SUBJECT: ISSUANCE OF AMENDMENT NO.132 TO FACILITY OPERATING LICENSE
NO. NPF-29 - GRAND GULF NUCLEAR STATION, UNIT 1 (TAC NO. M97520)

SUBJECT: ISSUANCE OF AMENDMENT NO.132 TO FACILITY OPERATING LICENSE
NO. NPF-29 - GRAND GULF NUCLEAR STATION, UNIT 1 (TAC NO. M97520)

AMENDMENT TO FACILITY OPERATING LICENSE

SAFETY EVALUATION BY THE OFFICE OF NUCLEAR REACTOR REGULATION
RELATED TO AMENDMENT NO. 132 TO FACILITY OPERATING LICENSE NO. NPF-29

Figure 3.4.11-1 (page 1 of 5)

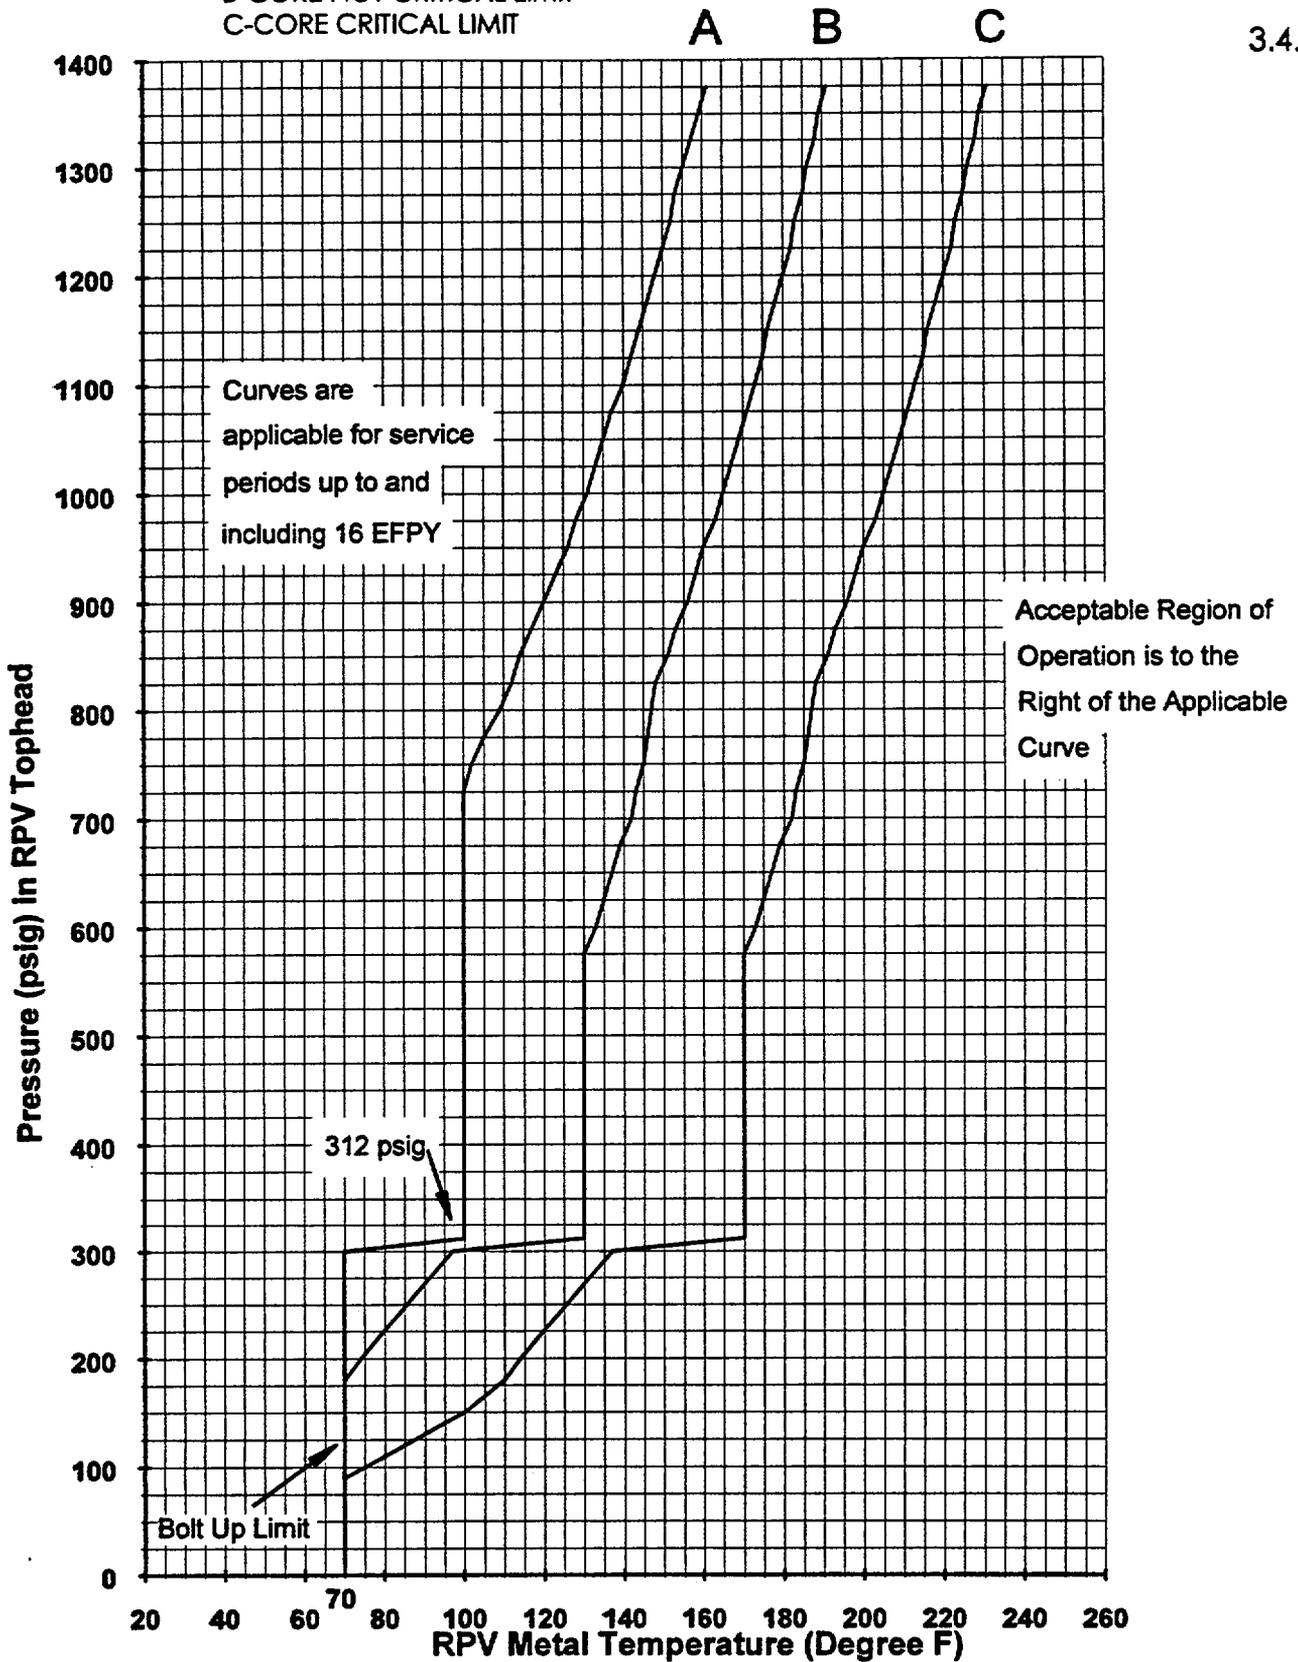
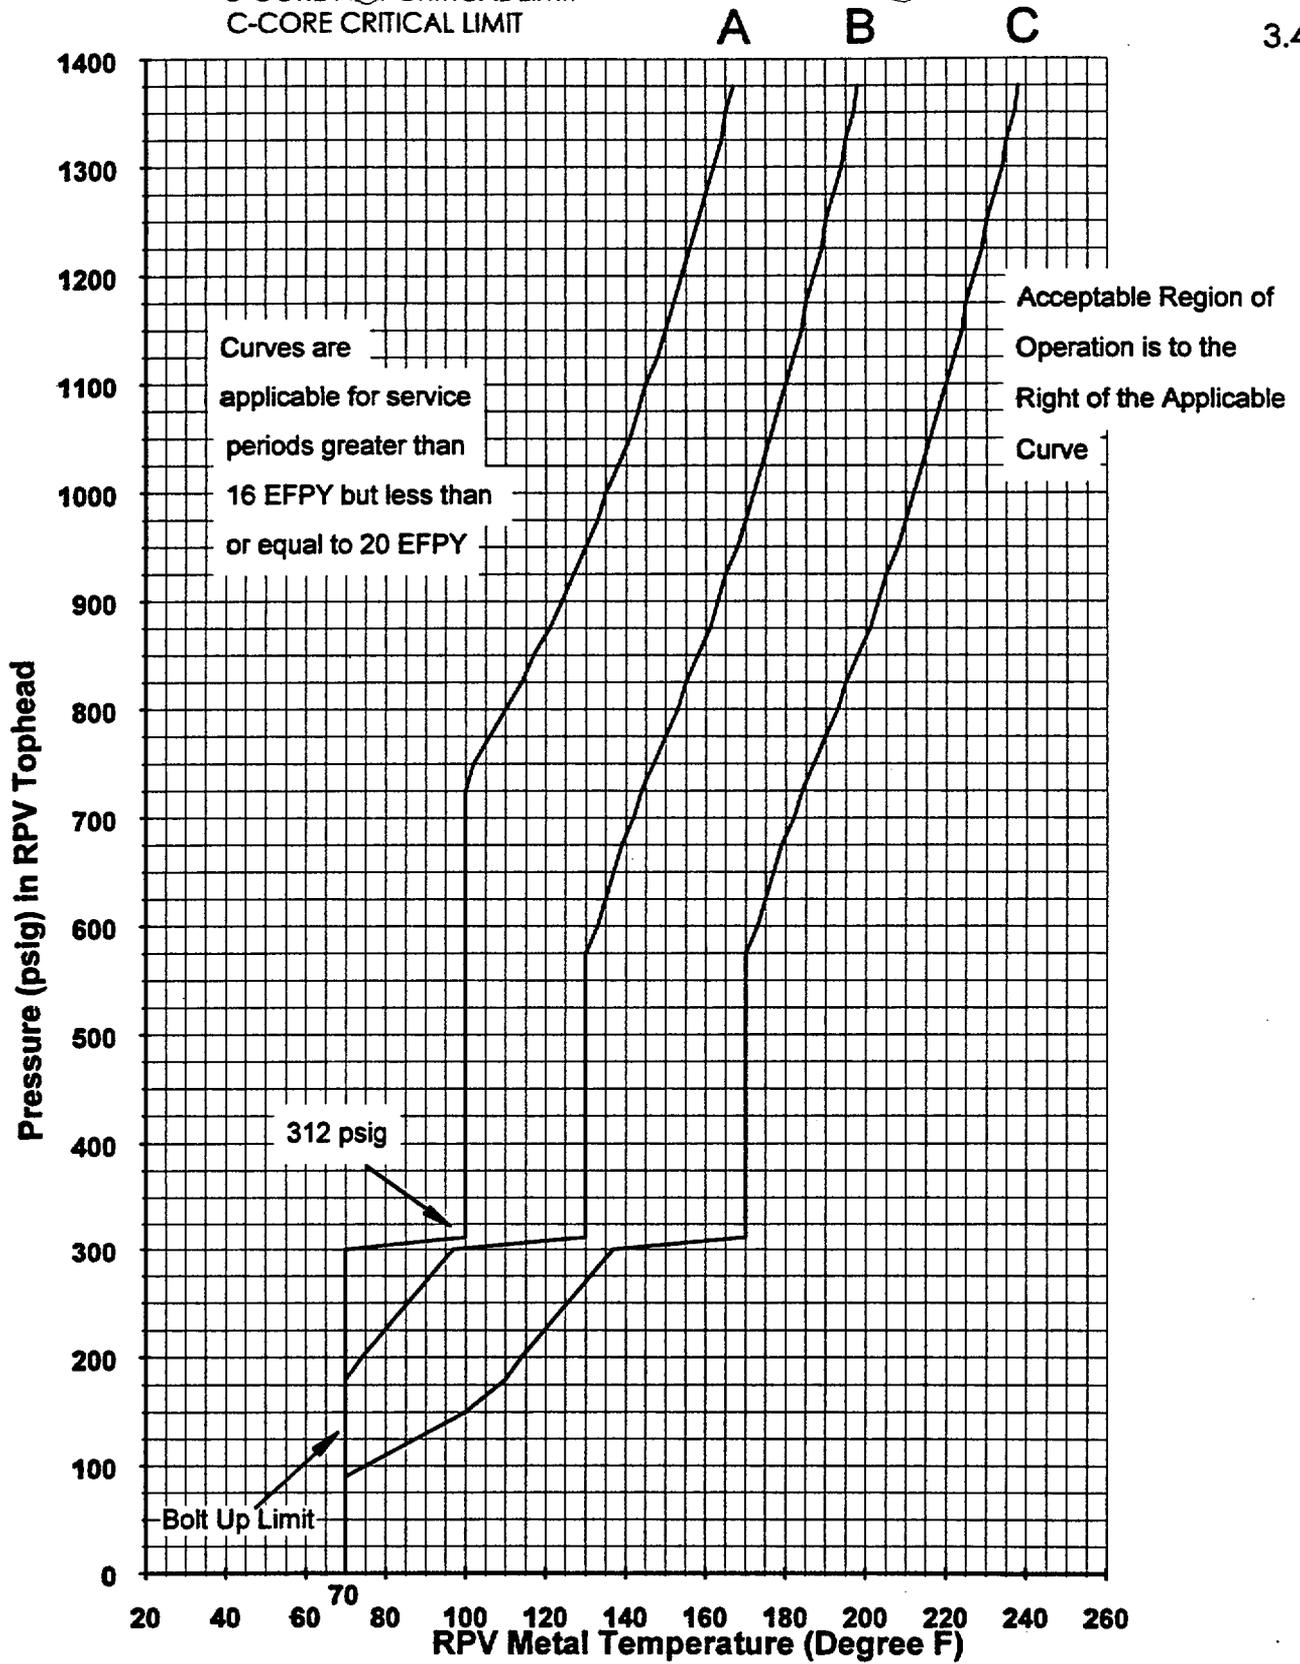
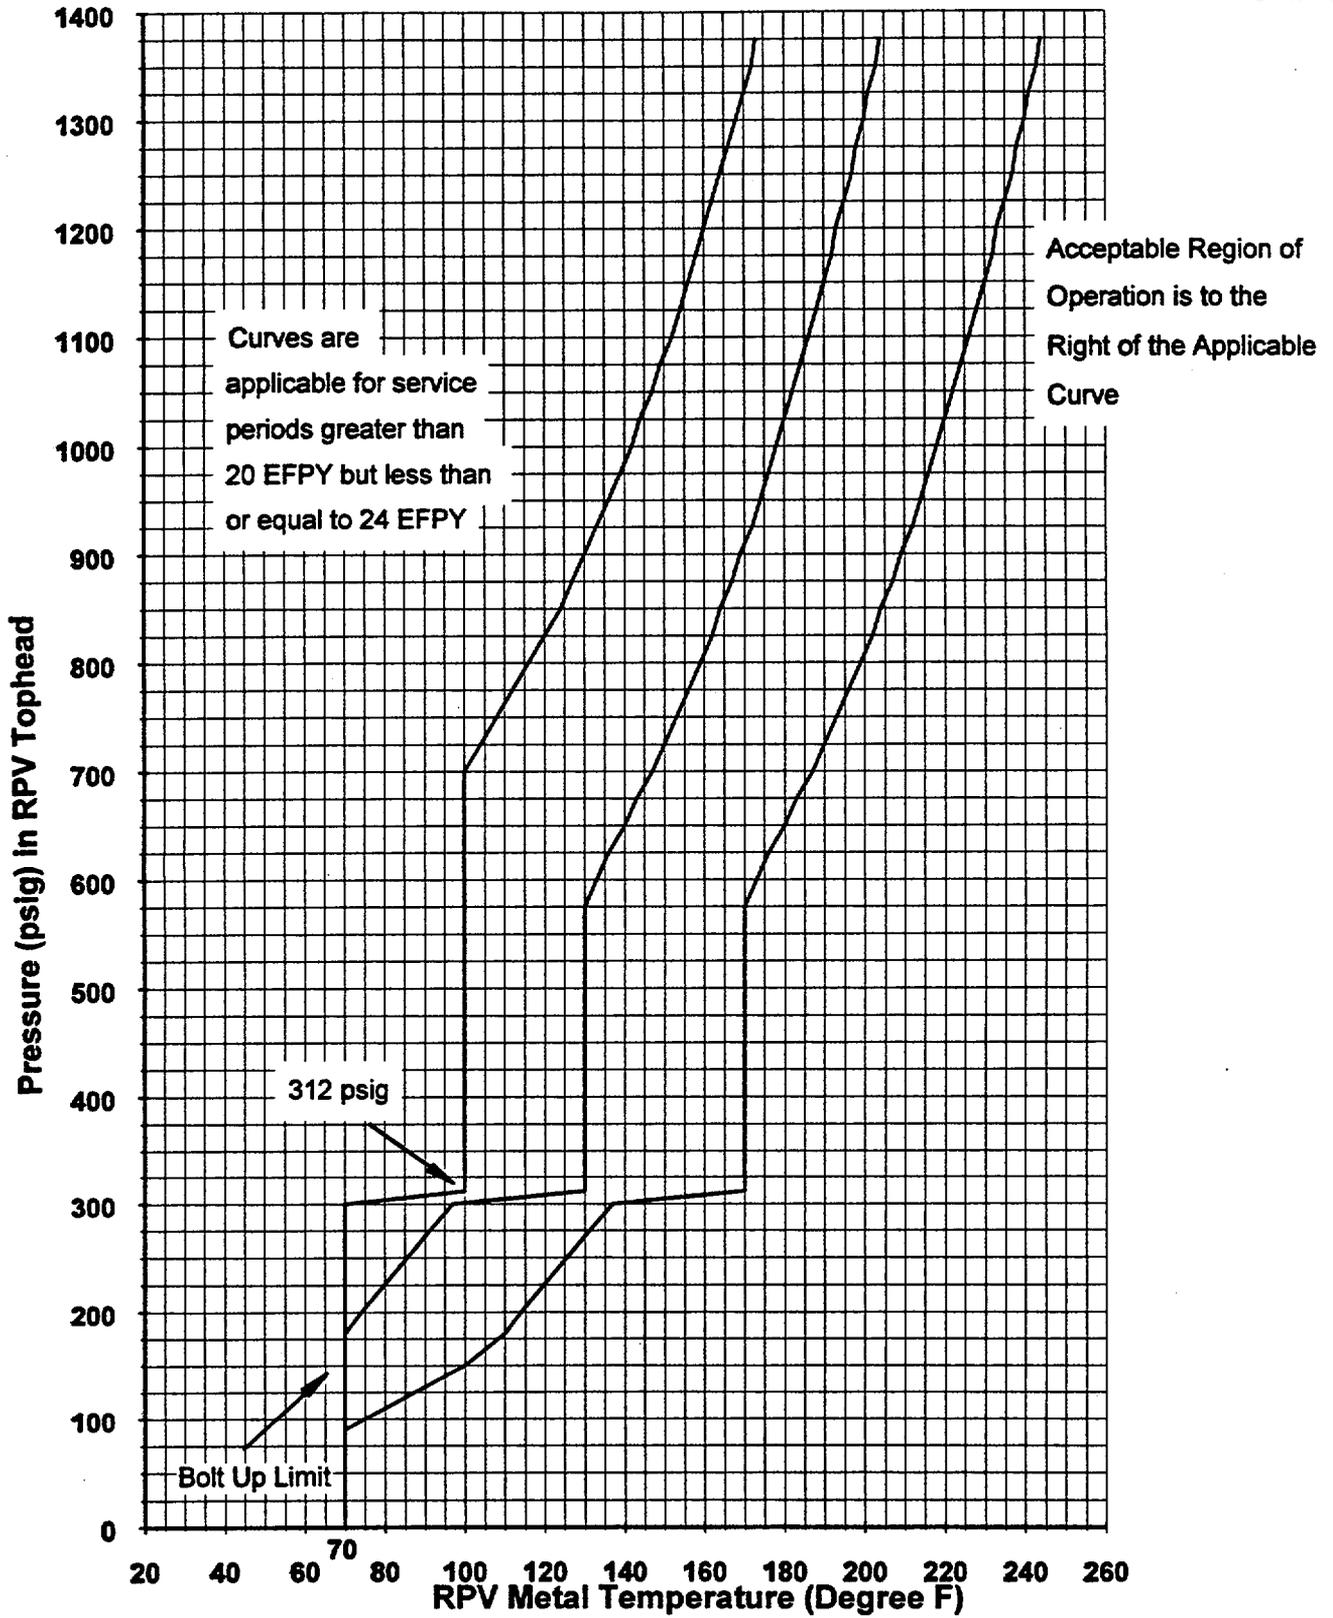
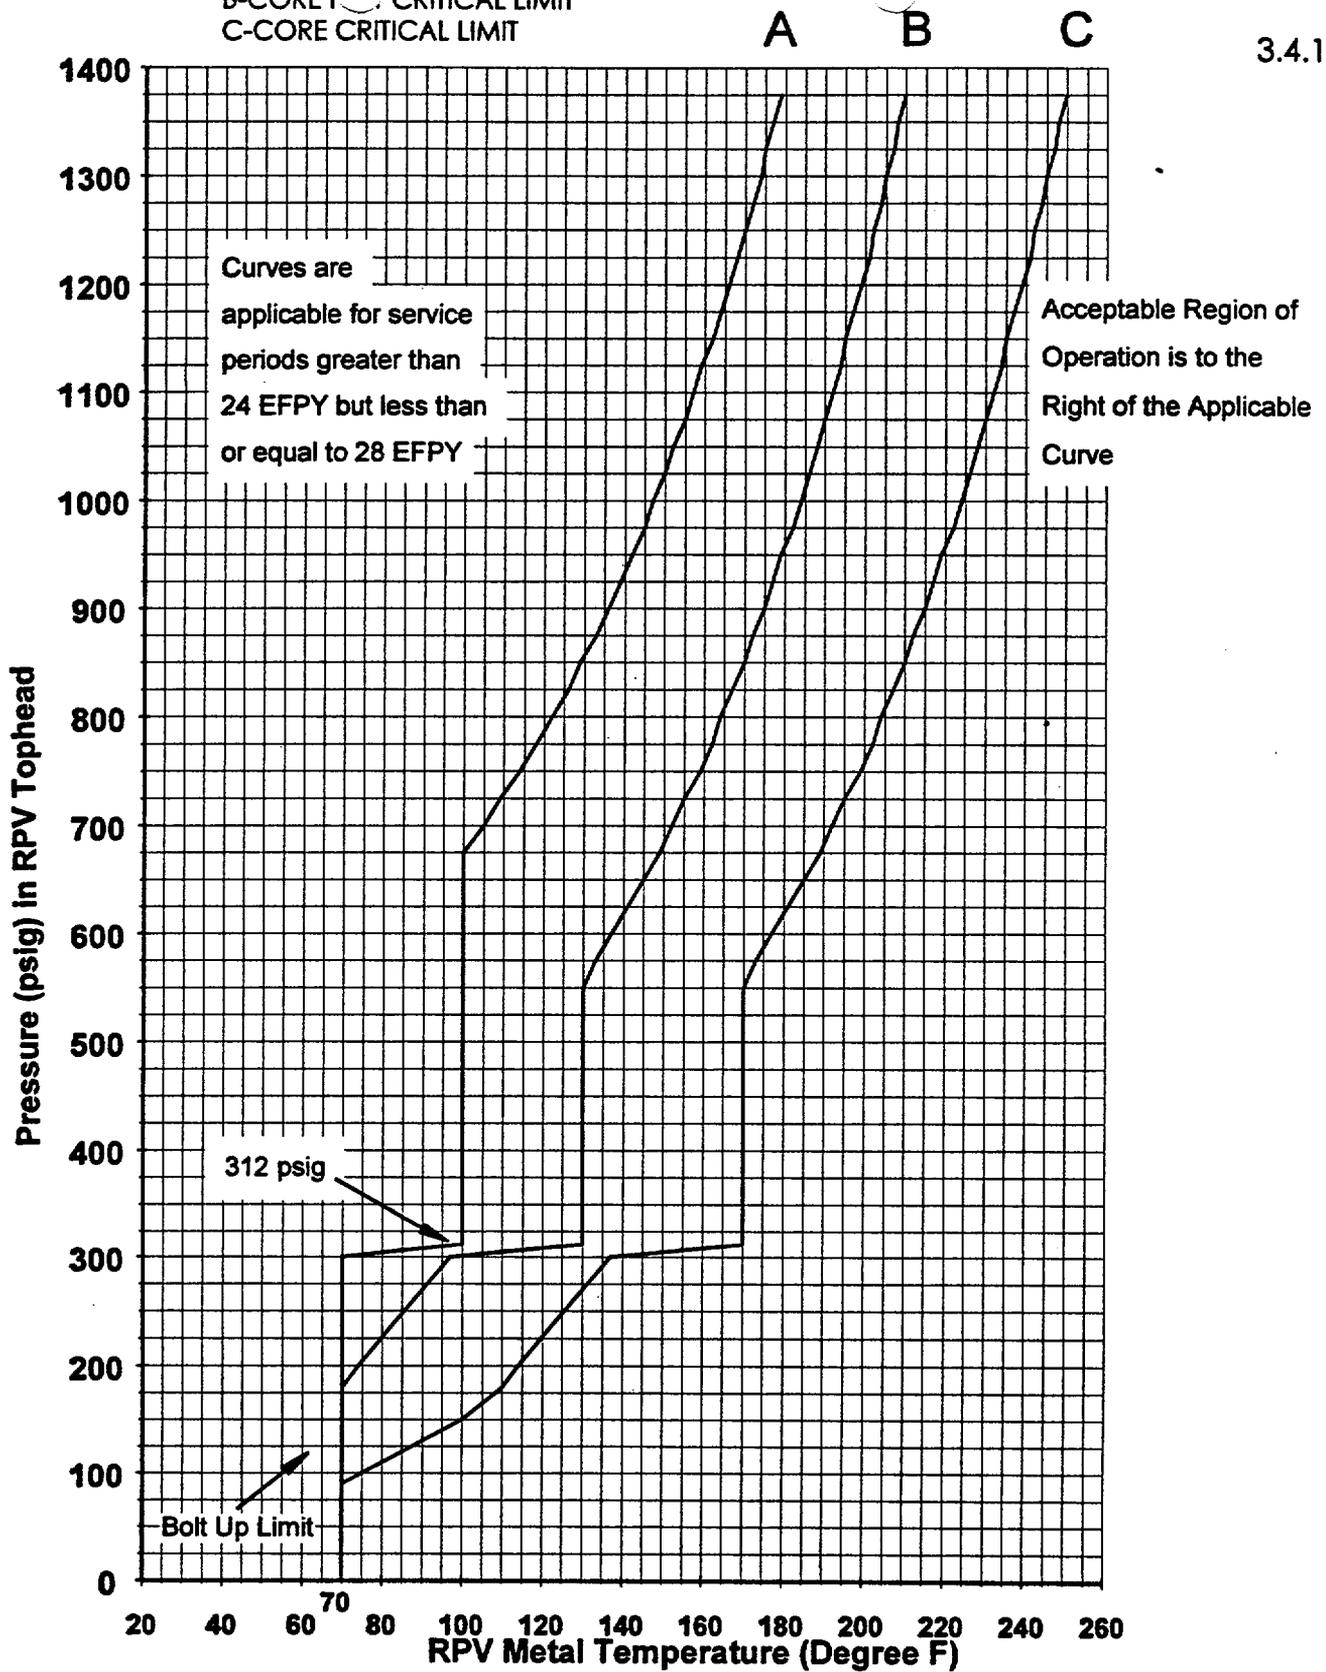
The amendment revised Figure 3.4.11-1 and Surveillance Requirements (SR) 3.4.11.1 and 3.4.11.2 of the TSs. The revisions to the pressure temperature (P-T) limits in Figure 3.4.11-1 extend the validity of the P-T limit curves from 10 effective full power years (EFPY) to 32 EFPY in increments. For each EFPY increment, there is a set of P-T limits in Figure 3.4.11-1 valid for the specified range of EFPY (i.e., Figure 3.4.11-1 is 5 figures). Further, paragraphs in the Bases and SRs in the TSs were revised to be consistent with the P-T limits. There are no commitments related to the amendment.

By application dated October 22, 1996, as supplemented by letter dated June 26, 1997 (References 1 and 2), Entergy Operations, Inc. (the licensee) proposed to amend Figure 3.4.11-1, "Minimum Reactor Vessel Metal Temperature vs. Reactor Vessel Pressure," and Surveillance Requirements (SR) 3.4.11.1 and 3.4.11.2 of the Technical Specifications (TSs) for Grand Gulf Nuclear Station, Unit 1 (GGNS). The proposed changes to the pressure temperature (P-T) limits in Figure 3.4.11-1 are to extend the validity of the P-T limit curves from 10 effective full power years (EFPY) to 32 EFPY in an initial increment of 6 EFPY, followed by constant increments of 4 EFPY (i.e., Figure 3.4.11-1 will be 5 figures). For each EFPY increment, there is a set of P-T limits in Figure 3.4.11-1 valid for the specified range of EFPY. Further, paragraphs under Bases and Surveillance Requirements in the TSs were revised by the licensee so that they will be consistent with the proposed P-T limits.

The staff evaluated the effect of neutron irradiation embrittlement on the beltline materials in the reactor vessels of Grand Gulf. The amount of irradiation embrittlement was calculated in accordance with RG 1.99, Rev. 2. The staff has determined that the material with the highest ART at 32 EFPY is the number (#) 2 shell axial welds, which was fabricated with weld wire heat number 627260, with 0.06% copper (Cu), 1.08% nickel (Ni), and an initial RT_{NDT} of -30°F . The ART calculated by the staff is 57.6°F at 1/4T for the limiting

material. The inner-diameter (ID) neutron fluence used in the calculation is $0.25E19$ n/cm² for 32 EFPY. This ART is the same as that calculated by the licensee. Substituting the ART of 57.6°F into equations in SRP 5.3.2, the staff verified that the proposed P-T limits (for 32 EFPY) for heatup, cooldown, and hydrotest meet the beltline material requirements in Appendix G of 10 CFR Part 50.

The licensee's fluence of $0.25E19$ n/cm² for 32 EFPY is not consistent with the corresponding value of $0.311E19$ n/cm² in NRC's reactor vessel integrity database (RVID). The licensee clarified in Reference 2 that the higher fluence value is the upper-bound fluence and does not need to be used in the P-T limits calculation. The licensee's P-T limits consist of 5 sets of curves, with EFPY values varying from 16 to 32 in a constant increment of 4 EFPY. The staff found that a linear relationship was assumed by the licensee to obtain ID fluence values for EFPYs less than 32. For additional assurance, the staff also verified the P-T limits for 16 EFPY in a manner similar to what is described above.

The major portion of the proposed P-T limit curves is defined by the beltline limiting material. However, certain part of the P-T limit curves is either bottom head or feedwater nozzle controlled. The methodology for these non-beltline regions was documented in Reference 2, and was found to be consistent with that used to support the P-T limits of Clinton (1996), Oyster Creek (1997), and Hatch (1997) nuclear power plants. This methodology was based on a finite element analysis of a generic BWR (Boiling Water Reactor) Type 6 vessel for an applied pressure of 1593 psig for the bottom head, and for the most severe transient with cold 40°F feedwater injection at normal operating condition (551.4°F and 1050 psig) for the feedwater nozzle. GGNS is a BWR Type 6 plant. The results from the generic analysis were then adjusted according to the plant-specific initial RT_{NDT} value of the bottom head or feedwater nozzle material. The staff determines that this methodology is consistent with WRC Bulletin 175 and the Appendix G of the ASME Code, and is acceptable to the staff.

Appendix G of 10 CFR Part 50 also imposes P-T limits based on the reference temperature for the reactor vessel closure flange materials. Section IV.A.2 of Appendix G states that when the pressure exceeds 20% of the preservice system hydrostatic test pressure, the temperature of the closure flange regions highly stressed by the bolt preload must exceed the reference temperature of the material in those regions by at least 120°F for normal operation and by 90°F for hydrostatic pressure tests and leak tests. Paragraph IV.A.3 of Appendix G states, "an exception may be made for boiling water reactor vessels when water level is within the normal range for power operation and the pressure is less than 20 percent of the preservice system hydrostatic test pressure." The staff examined the current and the proposed P-T limits, and found that this portion of the curves (straight line segments) remains the same. Therefore, the staff determined that the proposed P-T limits satisfy the requirements in Sections IV.A.2 and IV.A.3 of Appendix G.

The staff has reviewed the information provided by the licensee in its letters of October 22, 1996, and June 26, 1997 (References 1 and 2). The staff has determined that the licensee used methodologies consistent with Appendix G to 10 CFR Part 50, Appendix G to Section XI of the ASME Code, and SRP Section 5.3.2. Based on this determination, the licensee's proposed sets of P-T limits for heatup, cooldown, leak test, and criticality, which are valid for their specified EFPY ranges, may be incorporated into the TSs for GGNS. Further, the proposed bases and surveillance requirements are consistent with the proposed P-T limits. Therefore, the proposed changes to the TSs are acceptable.
